NOTES: (UNLESS OTHERWISE SPECIFIED)			PARTS LIST	
1. DO NOT SCALE FROM DRAWING. 2. REMOVE ALL SHARP EDGES, R.02 MIN. 3. ALL MACHINING FLUIDS SHALL BE WATER SOLUBLE AND FREE OF SULFUR, CHLORINE AND SILICONE, SUCH AS CINCINNATI MILACRON'S CIMTECH 410 (STAINLESS STEEL)	DIMENSIONS ARE IN INCHES		CALIFORNIA INSTITUTE OF TECHNOLOGY MASSACHUSETTS INSTITUTE OF TECHNOLOGY IGR, GLASGOW UNIVERSITY GEO 600 GROUP	
	TOLERANCES: .XX ± 0.01 .XXX ± 0.005		SYSTEM Adv. LIGO	
	ANGULAR ± 0.5 °		SUB-SYSTEM ETM & ITM SUS	
	MATERIAL		NEXT ASSY	
Ⓞ SCRIBE, ENGRAVE OR STAMP DRAWING PART NUMBER, REVISION ON NOTED SURFACE OF PART AND THEN A THREE DIGIT SERIAL NUMBER. SERIAL NUMBERS START AT 001 FOR THE FIRST PART AND PROCEED CONSECUTIVELY. USE .07" HIGH CHARACTERS. A VIBRATORY TOOL MAY BE USED. EXAMPLE: D020188-00 SN 001	FINISH μ inch		PART NAME RECYCLING MIRROR ENVELOPE	
	DRAWN	CIT	DATE	2006
	CHECKED			
	APPROVED			
SCALE: 1:24		PROJECTION:	SHEET 1 OF 1

SIZE DWG. NO. B D060102		REV. 01

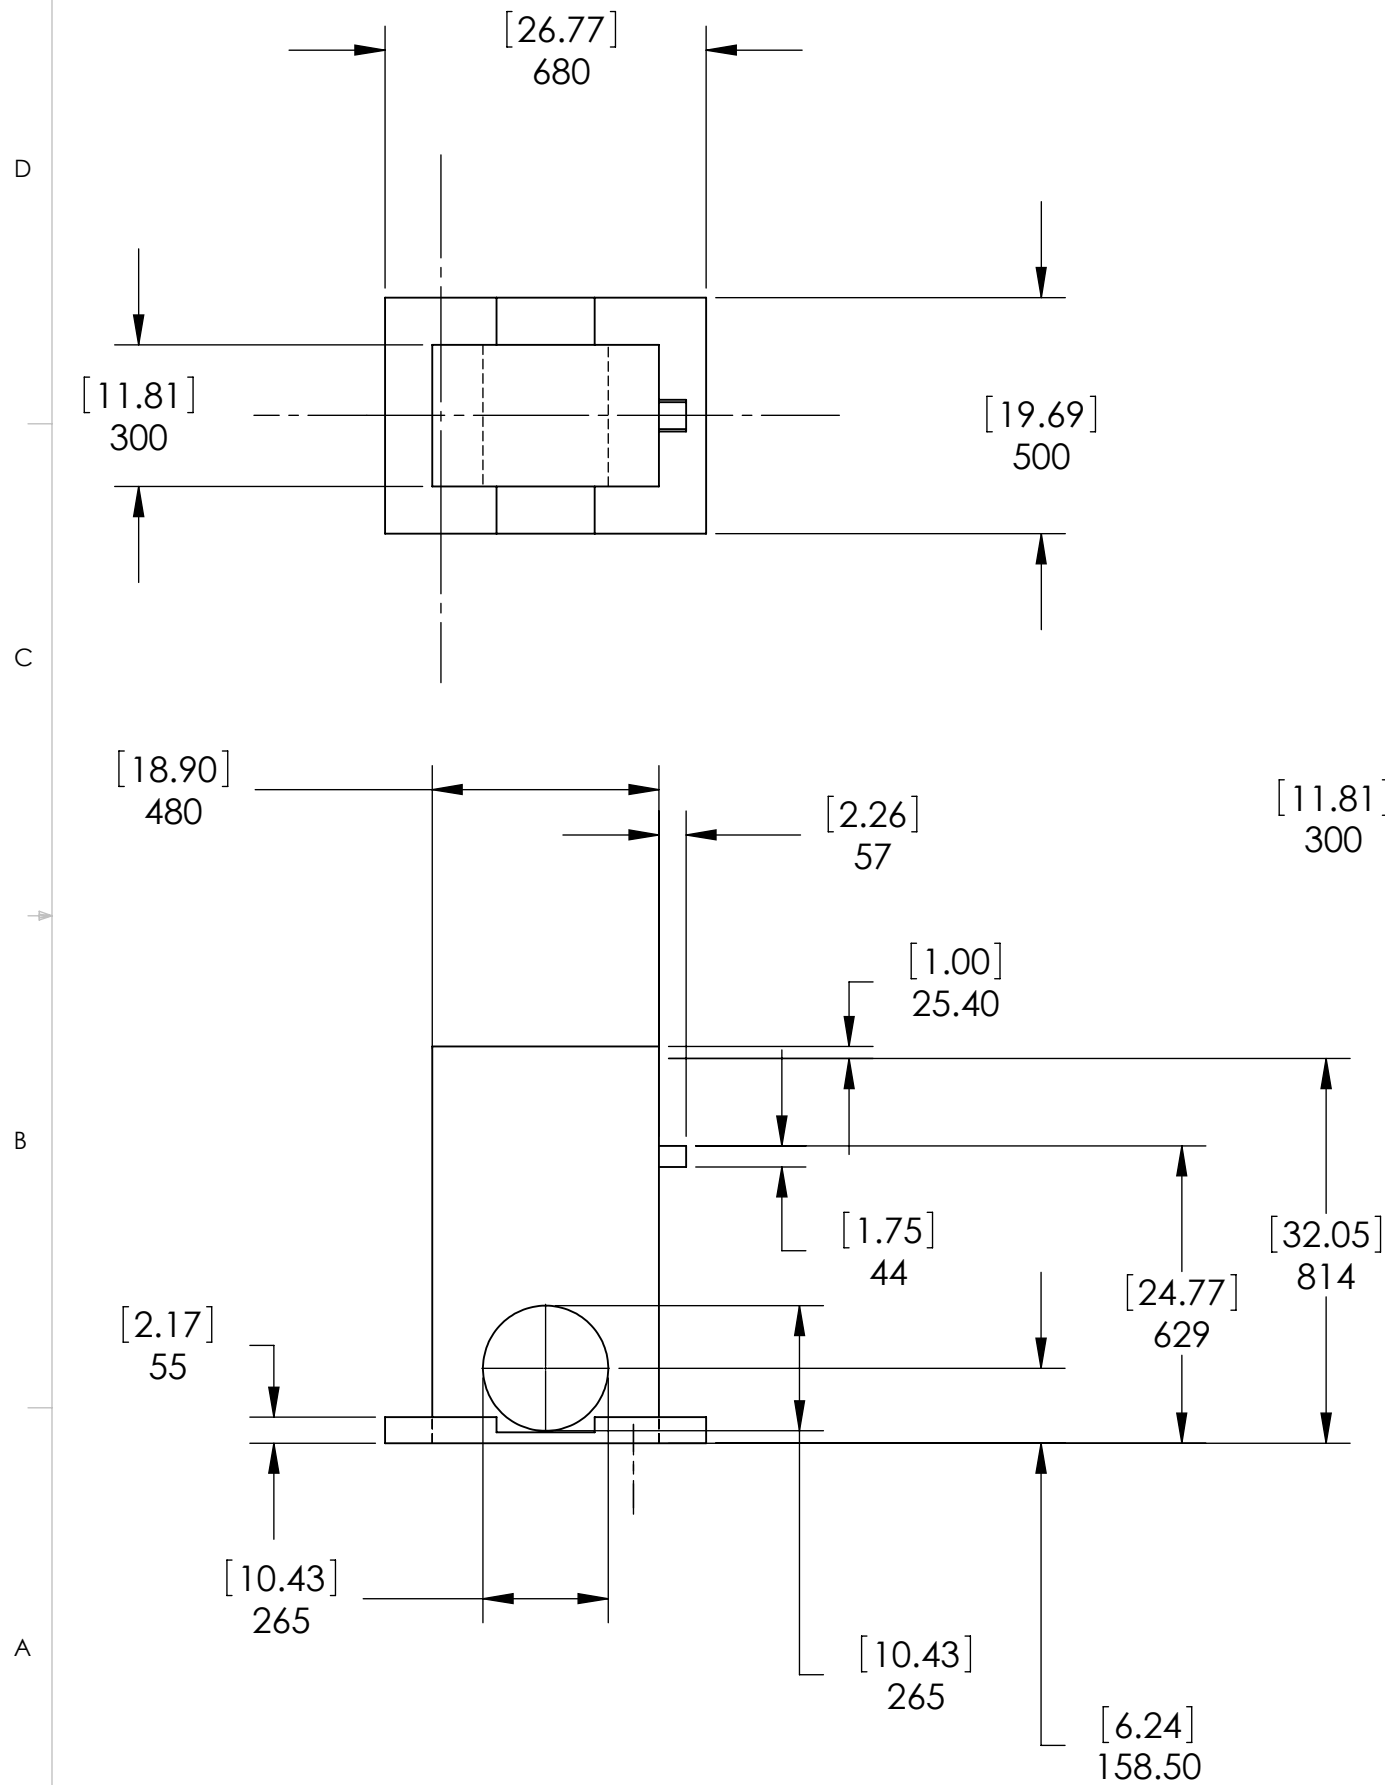
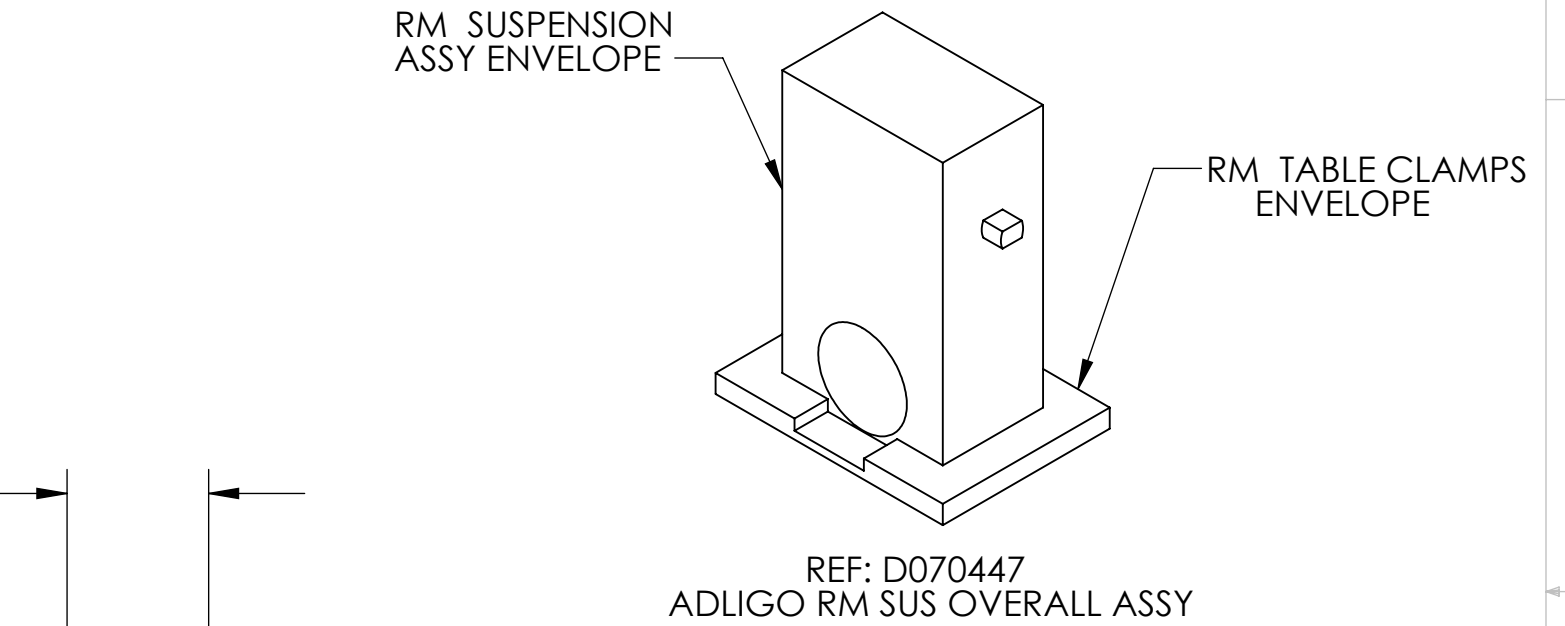
REV.	DATE	DCN #	DRAWING TREE #
01	1/15/08	UPDATED DIMS: 814 MM WAS 820MM 158.5 MM WAS 158MM ADDED OSEM & ITS DIMENSIONS
